**REPORT OUTLINE FOR AREA PLANNING COMMITTEES****Report No.**

<b>Date of Meeting</b>	27 <sup>th</sup> August 2020
<b>Application Number</b>	19/11239/FUL & 19/11801/LBC
<b>Site Address</b>	Dairy House Farm, Romsey Road, Whiteparish, Salisbury, SP5 2SF
<b>Proposal</b>	Proposed new swimming pool and outbuilding, new orangery and single storey link to existing lean-to accommodation, installation of new gates, retrospective addition of lean-to, summerhouse and decking
<b>Applicant</b>	Mr Shaun Wylie
<b>Town/Parish Council</b>	WHITEPARISH
<b>Electoral Division</b>	Whiteparish – Councillor Britton
<b>Grid Ref</b>	425658 123504
<b>Type of application</b>	Full Planning
<b>Case Officer</b>	Christos Chrysanthou

## Swimming pool

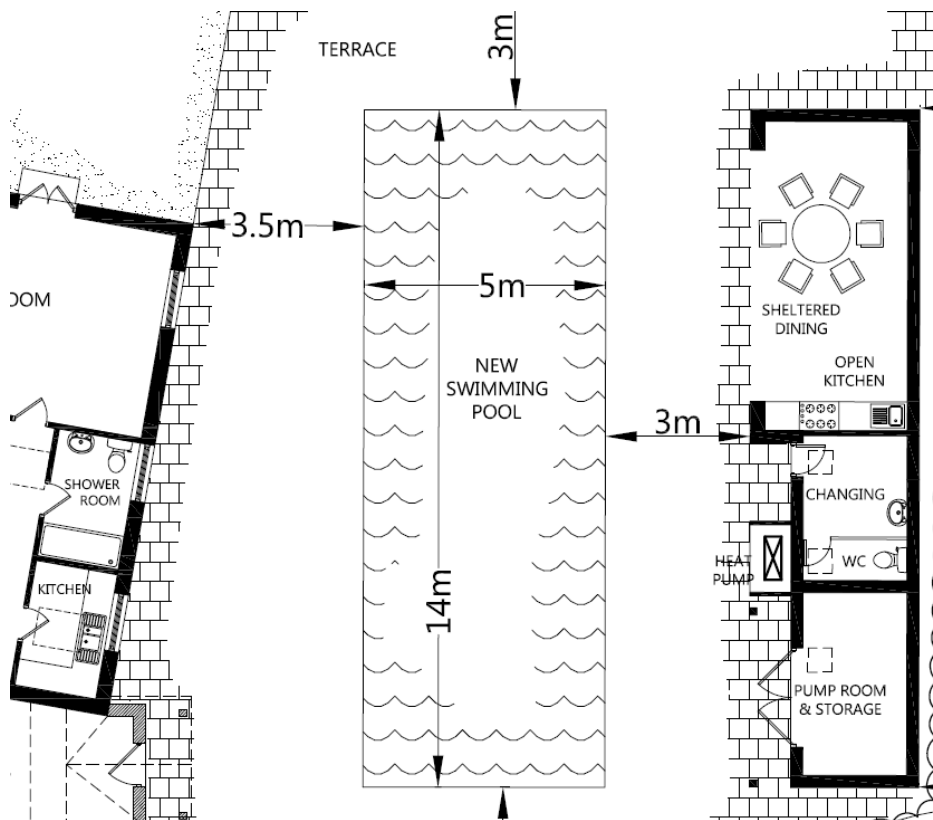
An outdoor swimming is proposed in the rear garden approx. 3.5m from the corner of the existing guest room extension to the barn/garage. The swimming pool is proposed to be 14m in length and 5m wide. The proposed swimming pool is within the curtilage of the dwelling and is considered acceptable.

## Outbuilding

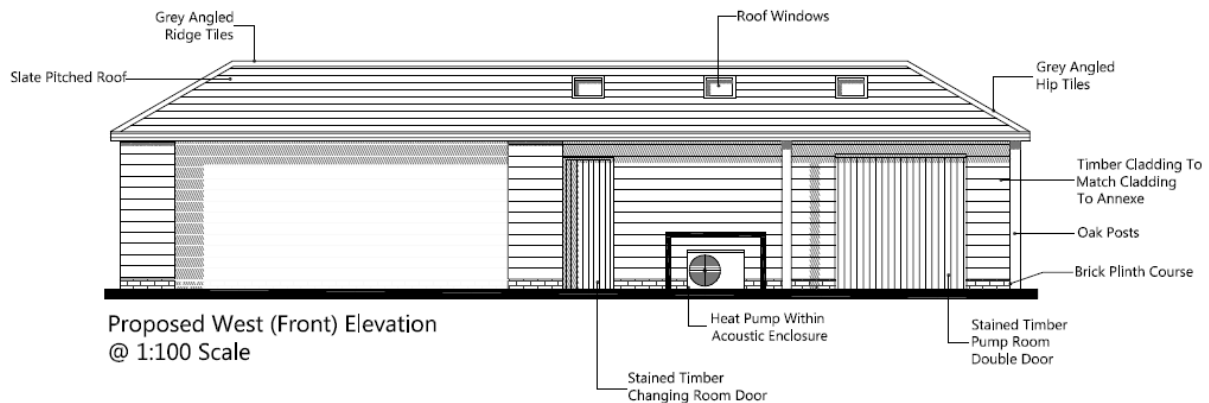
Sited directly parallel 3m to the east of the swimming pool, the proposed outbuilding has a width of approx. 14m and a depth of 3.5m. The height is approx. 2.5m to the eaves and approx. 3.5m to the roof ridge. The outbuilding would be set away 1.9m from the boundary. The revised plans have omitted a rear window. The floorarea consists of an open plan kitchen/dining area, a changing room and pump room/storage. The exterior materials consists of timber cladding on the walls above a brick plinth in addition to a slate roof with

grey angled ridge and hip tiles. The outbuilding is of limited scale and with appropriate materials is considered acceptable.

3 No development shall commence on site until details of the Natural slate roof tiles and the grey angled tiles to be used on the outbuilding hereby approved have been submitted to and approved in writing by the Local Planning Authority. Development shall be carried out in accordance with the approved details.

### Lean-to extension

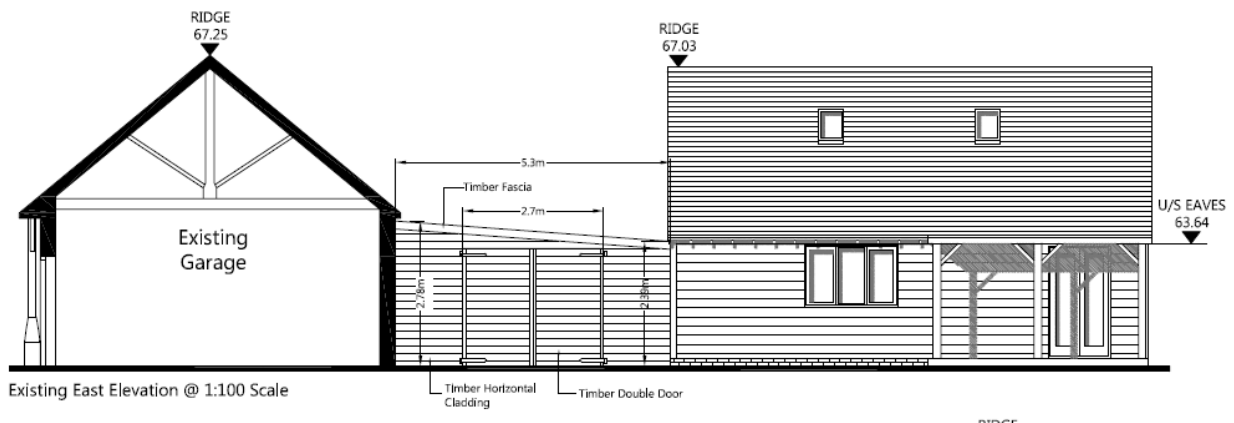
The proposal also consists of a timber frame lean-to storage area which is retrospective. The lean-to is sited to the rear of the existing barn/garage and provides a covered enclosure with timber clad walls, timber doors and a plastic corrugated roof covering. The rear wall of the enclosure is set away 8m from the boundary and the front wall is connected to the rear wall of the existing barn/garage and side wall of the adjacent store. The roof of the lean-to structure is set beneath the eaves of both the existing barn/garage and the adjacent store. The lean-to extension is considered acceptable.

### Summerhouse and decking area

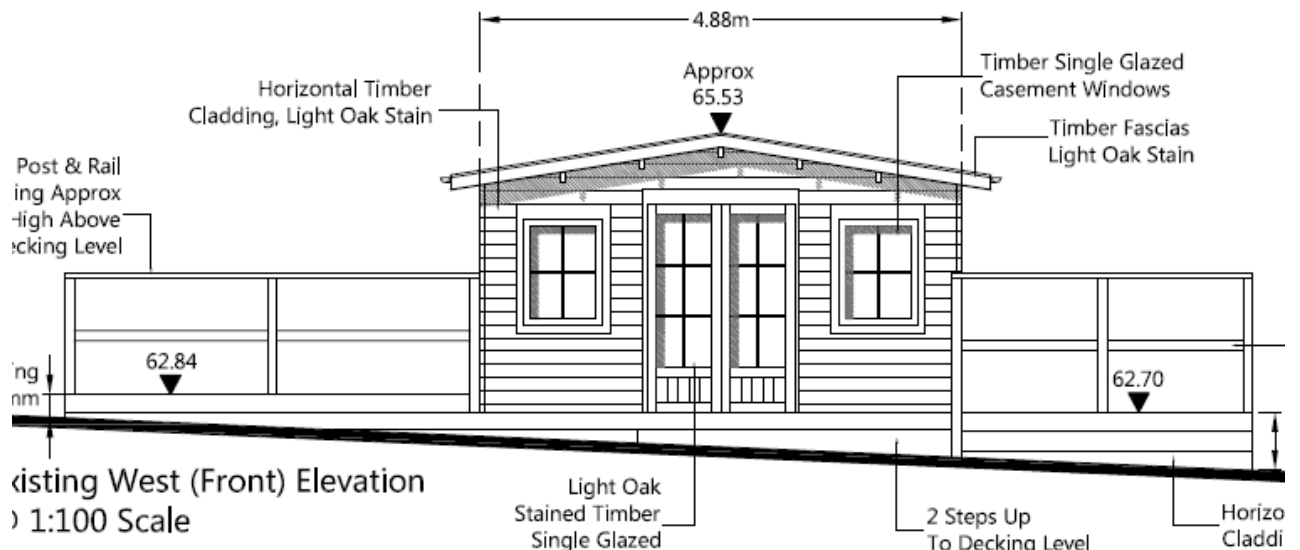
The proposal also consists of a decking area and summerhouse in the northeast section of the garden which are both retrospective. The decking area is set away approx. 1.3m from the boundary and occupies an area approx. 12m x 5m. Due to the sloping topography the decking is raised by approx. 60cm on one side and 20cm on the other. In roughly the centre of the decking area a timber summerhouse has been erected which is approx. 4.88m wide and 4m in depth. The height of the summerhouse is approx. 2.8m. The exterior walls are timber clad and the roof covered with felt shingles. The retrospective summerhouse and decking area are considered acceptable.

### Gates

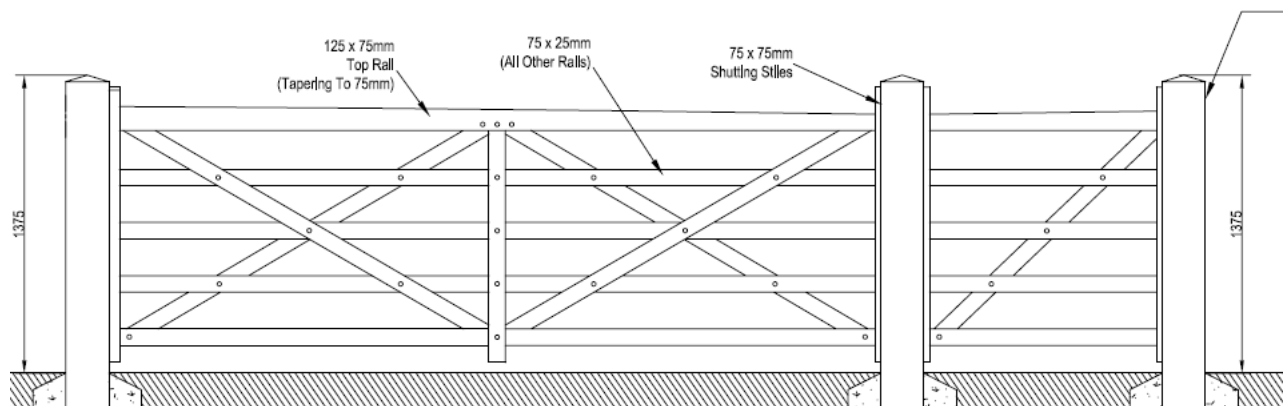
*In respect of my comments above, a revised proposed gate drawing has been supplied (19.034:16 Rev A) which shows a 6-bar gate with single pedestrian gate. I have no objection to this proposed design which is of a sufficiently rural character to preserve the setting of the listed building.*

A new 5 bar gate and pedestrian gate are proposed in a new position set back from the existing double gates which are to be removed. The posts are approx. 1.37m in height. The gates are proposed to be timber and of a traditional appearance suitable for the rural surroundings. The replacement gates as revised are considered acceptable.
